# MCF5282 User's Manual Errata

This errata document describes corrections to the *MCF5282 ColdFire Microcontroller User's Manual*, order number MCF5282UM. For convenience, the addenda items are grouped by revision. Please check our website at <http://www.freescale.com> for the latest updates.

MCF5282UMAD  
Rev. 13  
08/2006

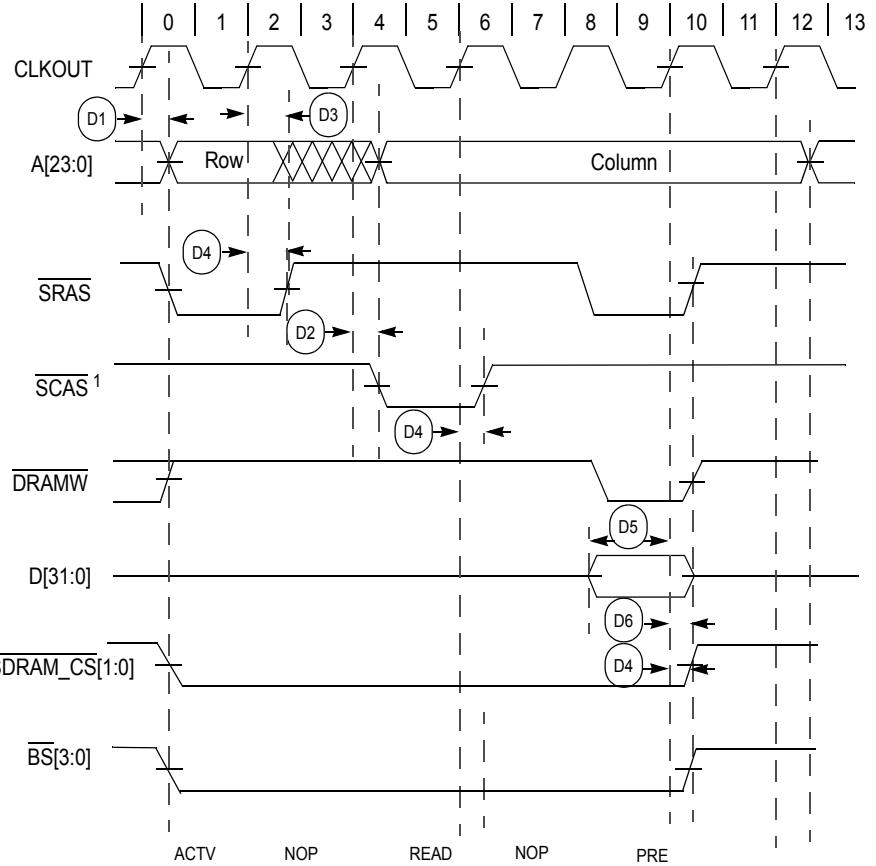
Location	Description
Figure 6-2/6-4	<p>Replace Figure 6-2, "CFM 512K Array Memory Map," with the figure below.</p> <p>The diagram illustrates the CFM 512K Array Memory Map. It shows a hierarchical structure of memory blocks:</p> <ul style="list-style-type: none"> <li><b>Physical Blocks:</b> There are four Flash Physical Block groups, each containing two physical blocks (2H[31:0] and 3L[31:0] for group 1; 0H[31:0] and 1L[31:0] for group 0). Each physical block is 128 Kbytes (32 bits wide × 32K).</li> <li><b>Logical Blocks:</b> Two Logical Block groups are shown: Logical Block 0 (256 Kbytes) and Logical Block 1 (256 Kbytes). Each logical block contains two physical blocks.</li> <li><b>Memory Arrays:</b> Each physical block is divided into two memory arrays: Memory Array 2H (2L[1:0]) and Memory Array 3H (3L[1:0] for group 1; 0L[1:0] for group 0).</li> <li><b>Configuration Field:</b> A shaded gray box labeled "Configuration Field (0x0000_0400–0x0000_0417)" is positioned between the physical blocks of Logical Block 0.</li> <li><b>Addressing:</b> Addresses 0x0003 FFFF and 0x0007 FFFF are shown at the top, with arrows pointing to the corresponding memory array blocks.</li> </ul>
